ADDENDUM NO. 2

This Addendum consists of the following **CHANGES TO THE BID DOCUMENTS FOR OFFICIAL NOTICE 14-2013:**

**2. SPECIFICATIONS FOR LINNWOOD PURIFICATION PLANT
WP-316: LINNWOOD OZONE BY PASS VALVES**

WP-316: Raw Water Pipe Inspections
Linnwood Avenue Water Purification Plant
3000 North Lincoln Memorial Drive
Milwaukee, Wisconsin

1. East Raw Water Discharge Line

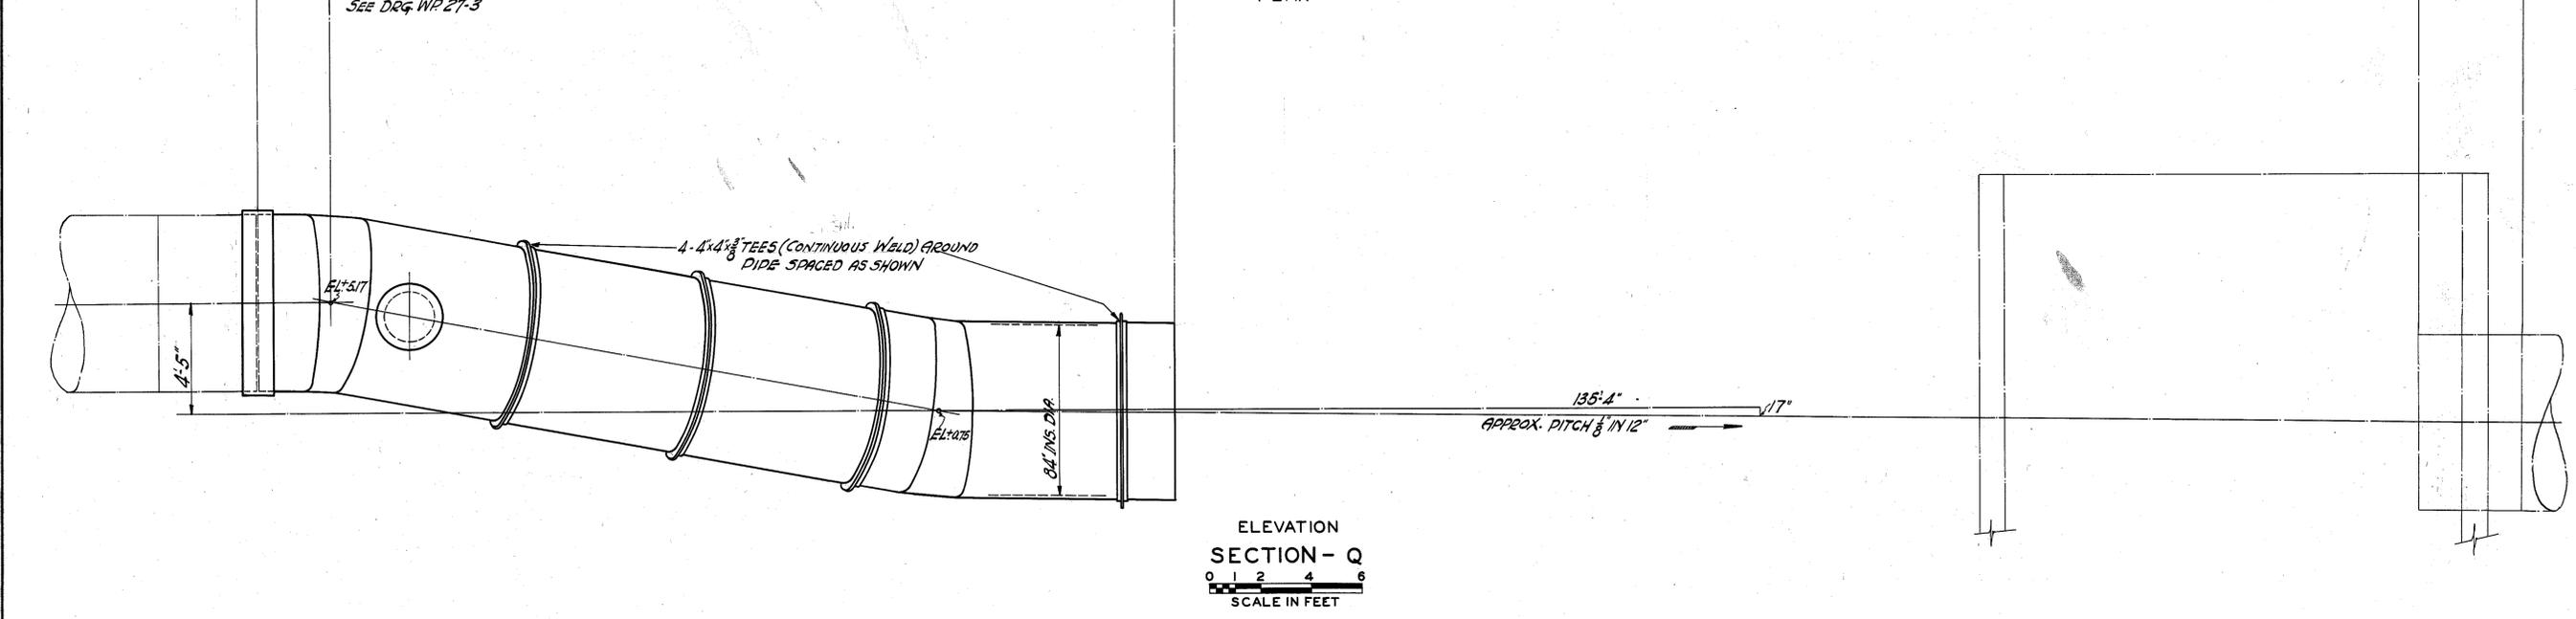
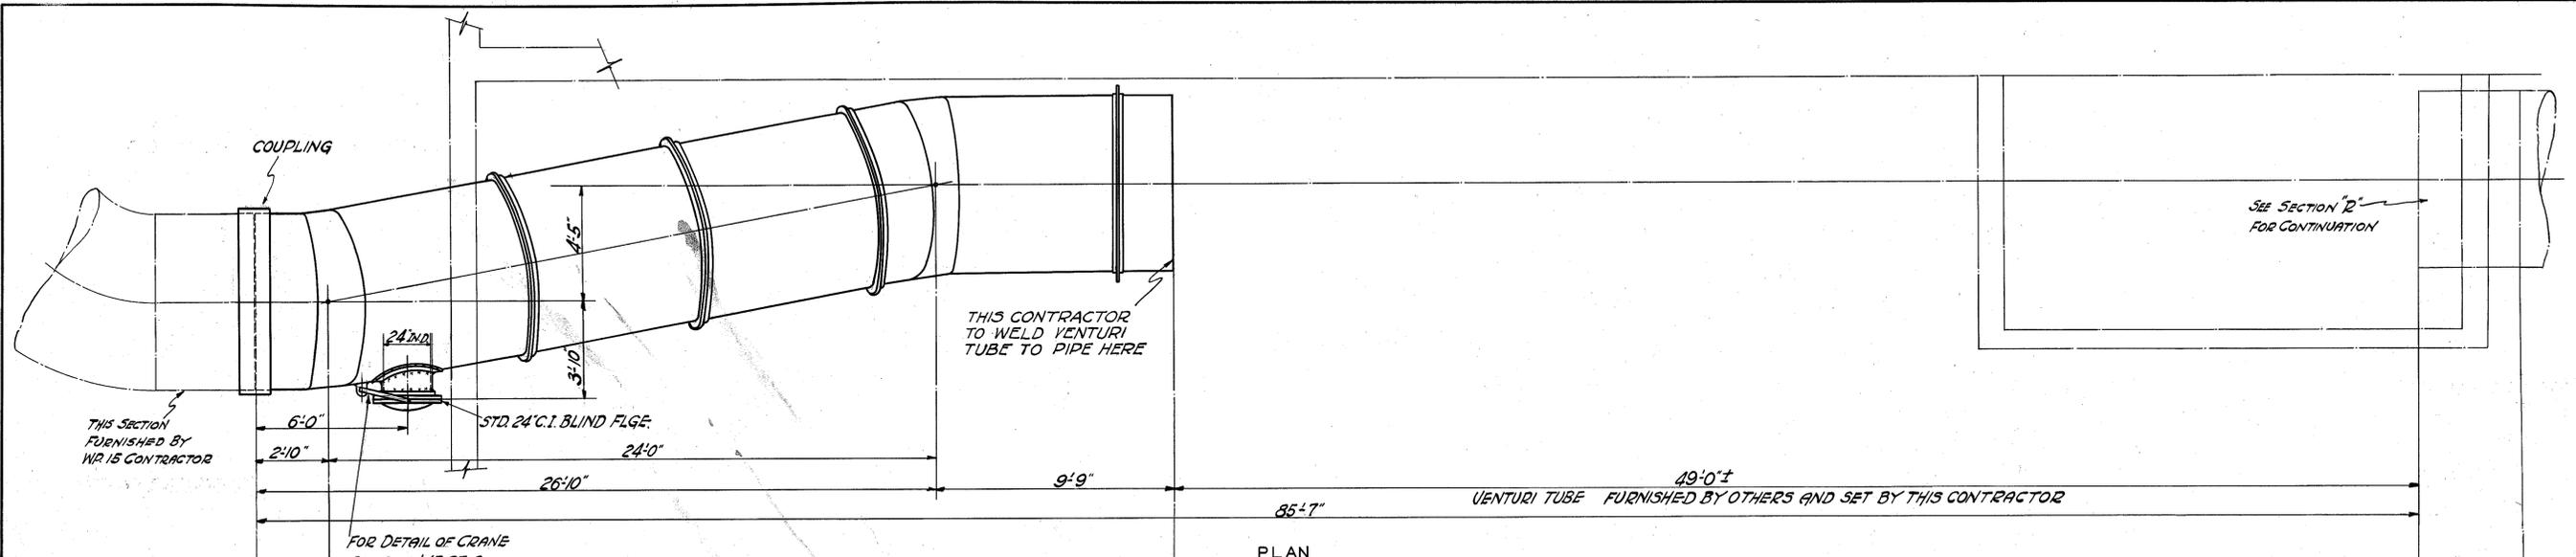
- A. The inspection and assessment of the 60" and 84" diameter raw water discharge piping from the removal point of the existing 60" diameter balance valve to the east north balance valve located in the northern part of the main pump room building; through the discharge tees for raw water pumps 4, 6, and 8; through the 90 degree bend and to the 60" diameter butterfly valve. The estimated length of this inspection is 135 feet.

- B. The inspection and assessment of the 72” and 84” diameter raw water discharge piping from the removal point of the existing 60” diameter balance valve to near the entrance to the north coag basin; through the reducers and 45 degree bends entering into the pump building; through both 90 degree bends; up to the closed 30” diameter crossover valve; passing through the 84” x 30” venture meter and ending at the 24” diameter manway access to the pipe. If inspection through the existing venture meter is not possible, the line shall be inspected up to the venture meter from each side. The estimated length of this inspection is 320 feet.

CITY ENGINEER'S OFFICE, MILWAUKEE, WIS.
MILWAUKEE WATER WORKS
WATER PURIFICATION PLANT
SUBSTRUCTURES AND PIPING
PUMP PIPING
CLEAR WELL RUN - NORTH HALF

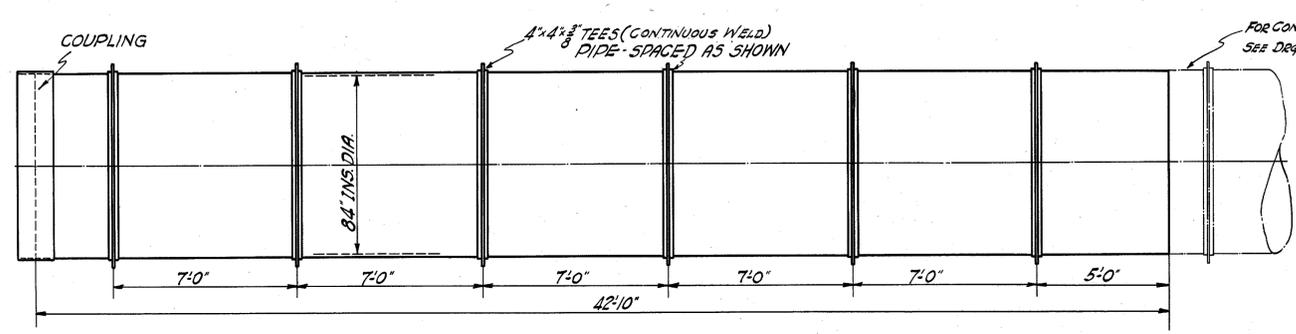
6. The following additional drawings are attached to supplement the original reference drawings:
- WP-27-2 – Pump Piping – Clear Well Run North Half
 - WP-27-3 – Pump Piping – Bends at Clearwell

CITY ENGINEER'S OFFICE, MILWAUKEE - WIS.
 MILWAUKEE WATER WORKS
WATER PURIFICATION PLANT
 SUBSTRUCTURES AND PIPING
PUMP PIPING
 CLEAR WELL RUN - SOUTH HALF

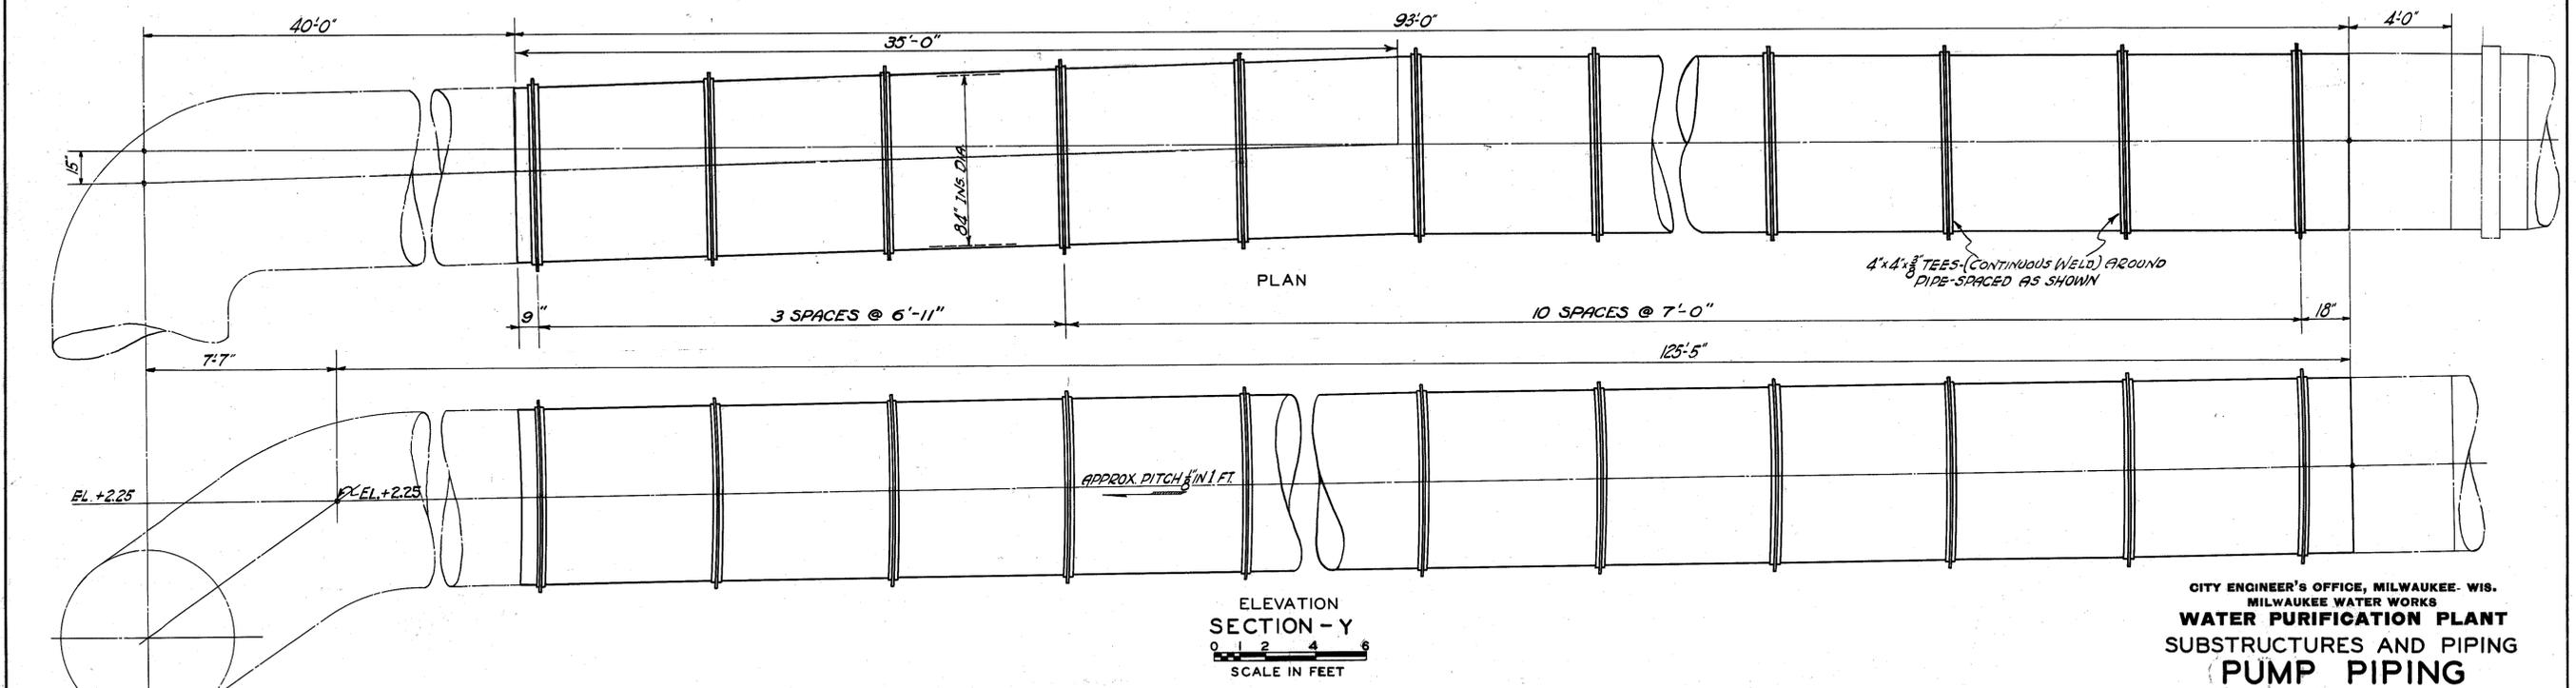
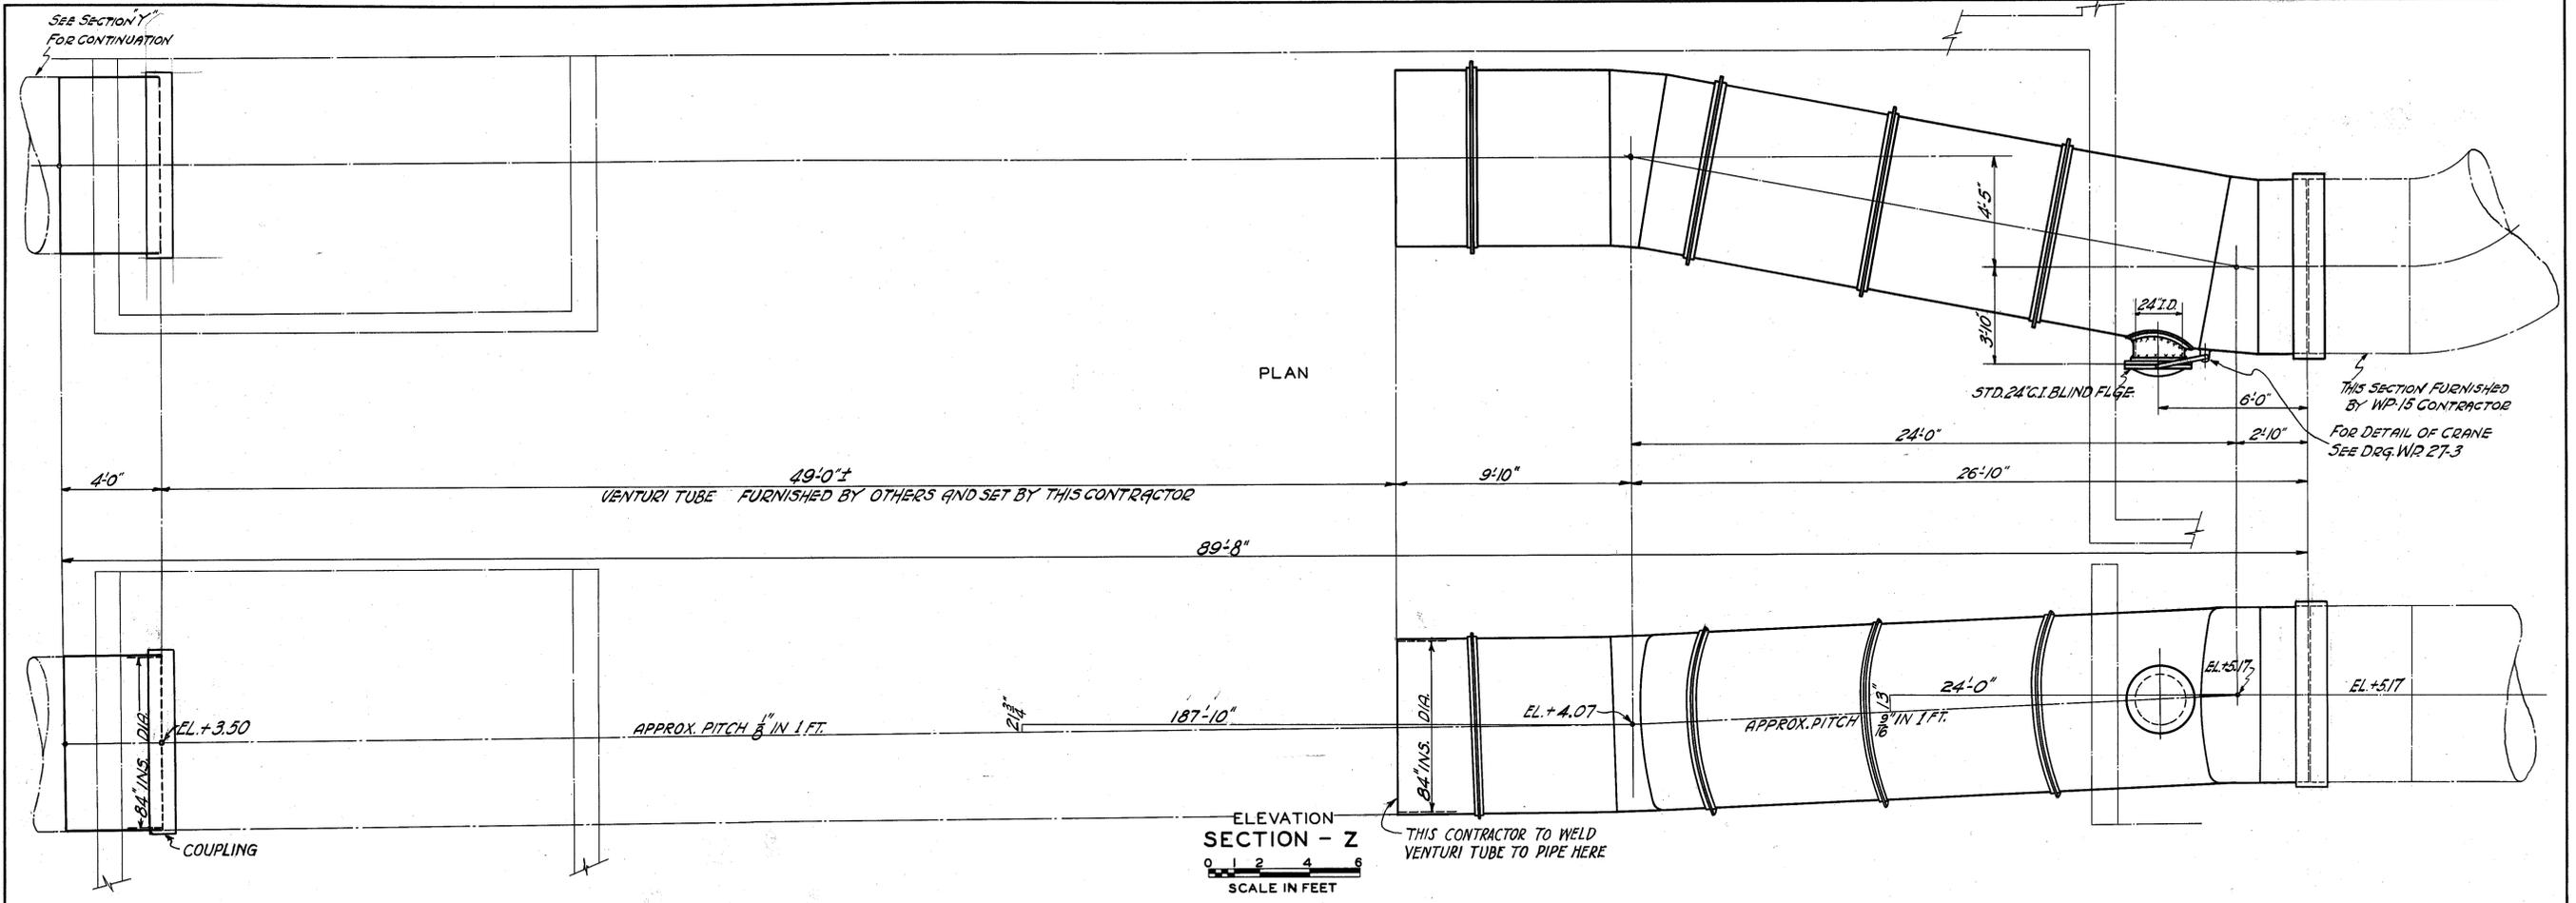
- WP-27-7 – Pump Piping – Clearwell Run South Half
